**EA0607-002 Tamerlane Ventures
Inc.'s
Pine Point Pilot Project (PPPP)**

**Second Round Information
Responses from
Tamerlane Ventures Inc. to the
MVEIRB**

Submitted August 15, 2007

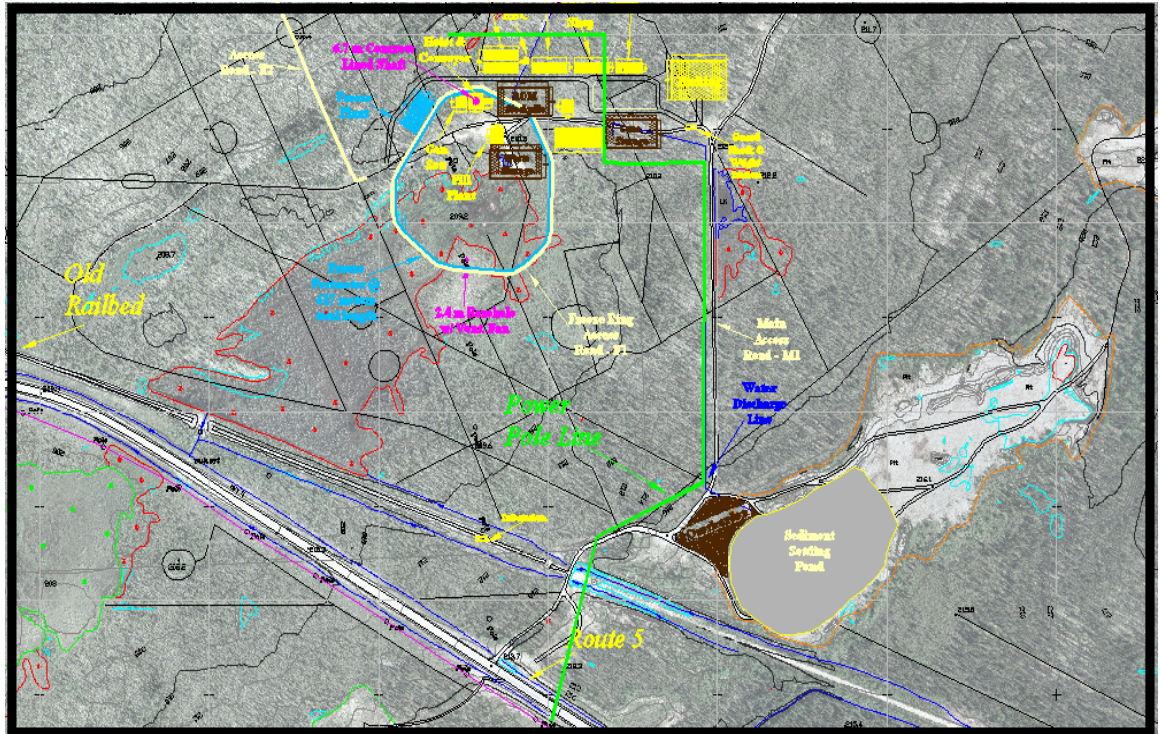
1. Confirm that the developer will be utilizing power accessed from Northland Utilities existing grid as the primary power source for this development, and whether the previously proposed diesel generation plant still will be utilized, its size and role in the operations.
2. Identify the likely mixture of diesel and hydro-electric power usage during the construction and operations phases of the PPPP, and different air quality scenarios associated with usage of diesel vs. hydro-electric power.
3. Indicate on a map the committed to routing of power lines onto the site, and any mitigation against impacts on wildlife.

3. During a site visit with Norhland Utilities on July 10th, 2007, a best case scenario routing was identified that will mitigate highway exposure and land exposure. As indicated in the map below, the line (highlighted in green) will cross the highway at already elevated locations and then be routed along the access road to mitigate any additional clearing and provide Northland Utilities maintenance access. Additionally, please see the below correspondence regarding Tamerlane's continuing commitment to mitigate any environmental concerns:
-

I had a productive meeting with several key personnel with Northlands Utilities yesterday. Keeping in mind with your concerns and suggestions, we have traced out a location for the power lines that will NOT cross or interfere with any fen areas nearby. We chose an area that is high and dry. The power poles will be ~35' high. It appears that in some areas, this will be higher than the surrounding tree line, therefore, I have already informed Northlands that we may want to put markings on them. The good news is that the new location for the power line has no corners or bends and will be bordered on either side by trees, thus not in any landing or take-off zone near any fen areas.

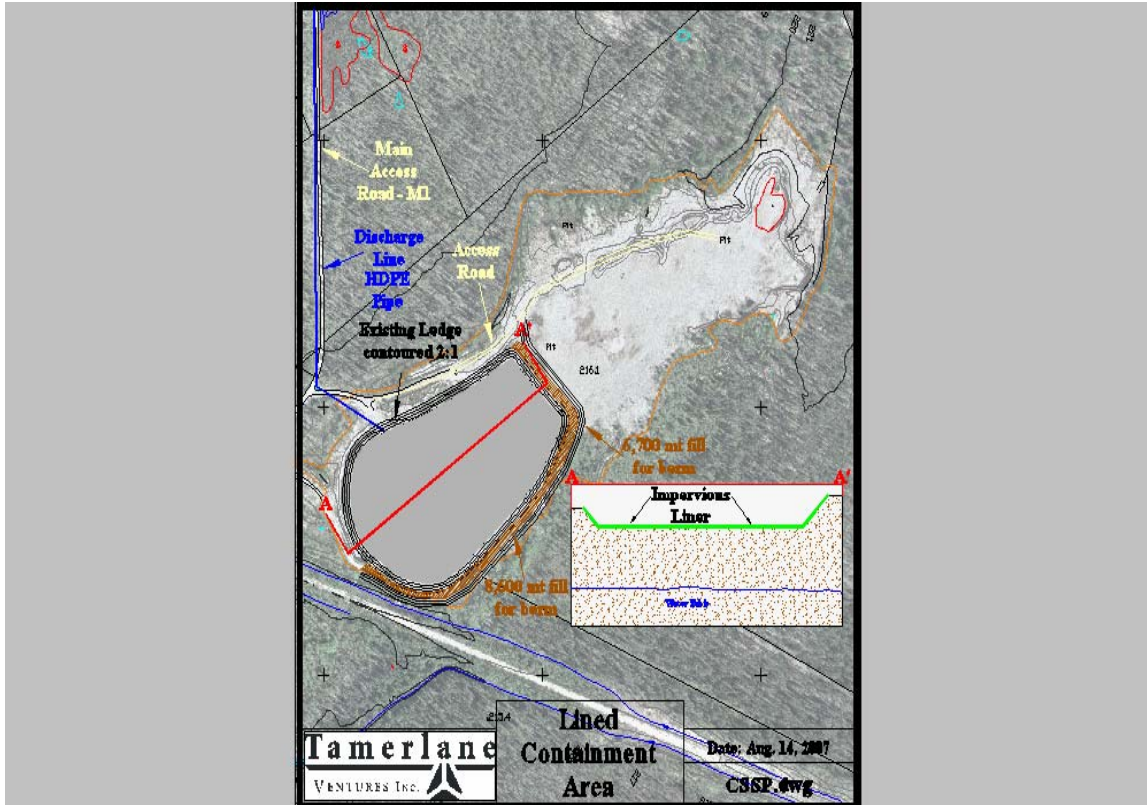
3. Will a settling pond be used to remove materials that could contribute to plugging of the well? If so, provide details of pond location, construction and operation.

3. Please also refer to IR0607-002-45, response #2. As shown in the below diagram, berms will be constructed on the North and East side of the pond utilizing 6,700 and 8,600 metric tonnes of fill respectively. The South and West banks will be sloped with the remaining berms at a 2:1 angle. An impervious liner will be laid out and fitted together throughout the pond and up the slopes. A thin layer of gravel or waste rock will be laid over the top of the liner to act as protection against puncture.

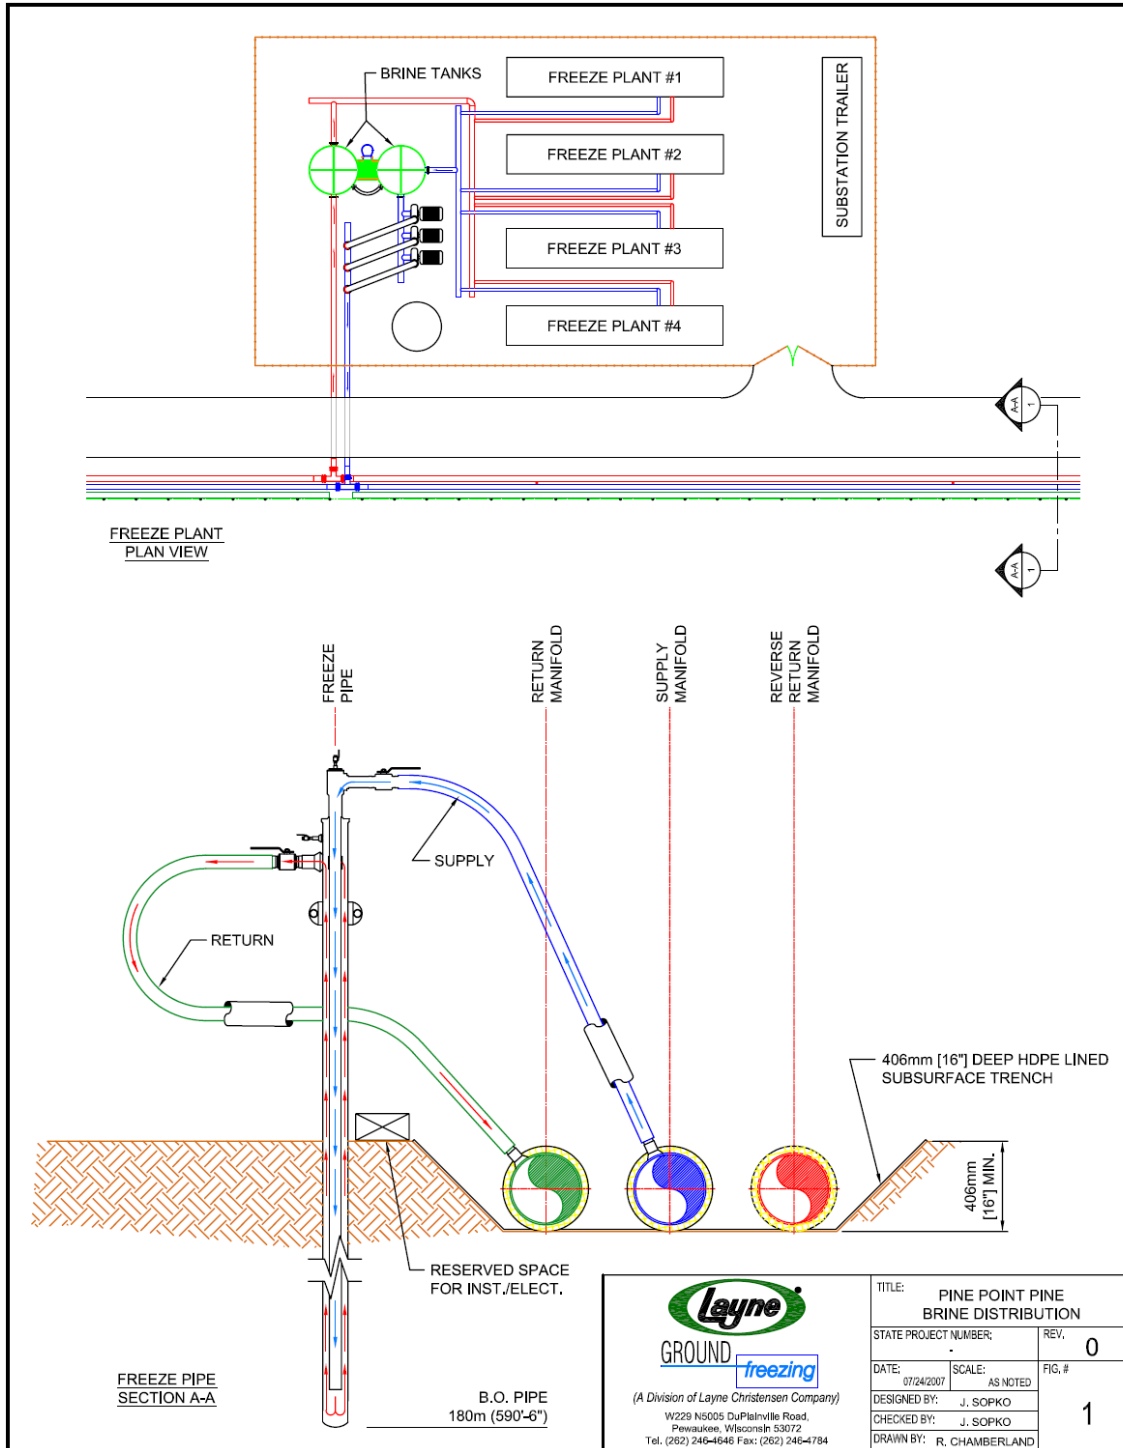
1. Develop, propose and describe design measures to ensure that the refrigeration fluid is at all times contained within the distribution system, even in the event of total rupture of the brine distribution system. Tamerlane should provide information that demonstrates that the containment system(s) have sufficient capacity for complete rupture without release of any refrigerant to the environment. In this analysis, for example, identify whether the lined drainage ditch extends around the entire freeze ring or is limited to the main manifold section only.

2. Provide information and evaluation that indicates the quantity of brine that might be lost due to an underground failure of the mined system (e.g., loss of brine from one of the “down pipes”), and the likely area of influence on local groundwater quality from such an occurrence. Describe response measures that would be proposed to prevent this brine creating an unacceptable environmental impact.

1. Tamerlane will be adhering to the following around the freeze ring perimeter: [The simplest and most effective way to contain the brine within the manifold is to set the manifold in a HDPE-lined trench that will serve as a reservoir for any spills. The proposed manifold is composed of three 12-inch diameter pipes making up the supply, return and reverse return manifold. The combined volume of the manifolds is 34,700 gallons while the volume of the lined trench is 111,100 gallons. A drawing of this system is provided below.](#)
